New Hinge for Heavy Duty doors & hinged side panels as well as FCC doors

New Flush Hinge

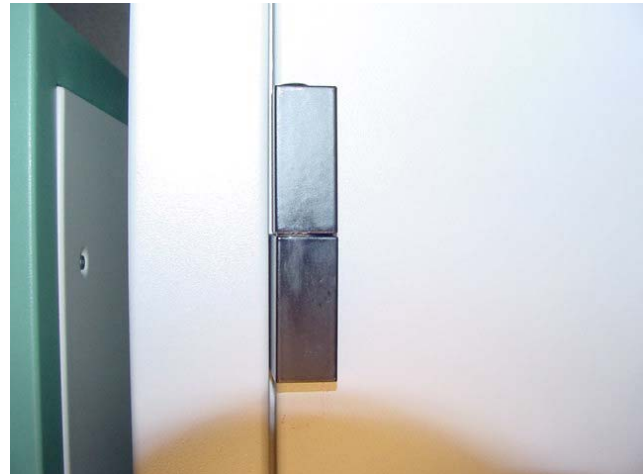
Equipto Electronics will be changing the hinges used on the doors and hinged side panels in their Heavy Duty line as well as used on the doors in their FCC line. Aside from ease of manufacturing and installation of the doors or hinged sides at the factory, this change will allow for more adjustability in the doors when replacing a door. Aesthetically the new hinge is more up-to-date as well. The new and old hinges are both shown in the pictures below:

For a short time the *old hinge* will still be available on a custom basis. This means that the door or hinged side panel would become a custom item and be priced and scheduled as a custom item. The doors are not interchangeable between old and new. The drilling pattern on the frame is different and the manufacturing of the door is different.

This change will be effective for material shipped after 12-31-04. All new custom Heavy Duty doors, hinged side panels & FCC doors quoted after 11-1-04 will be quoted with the new hinge.
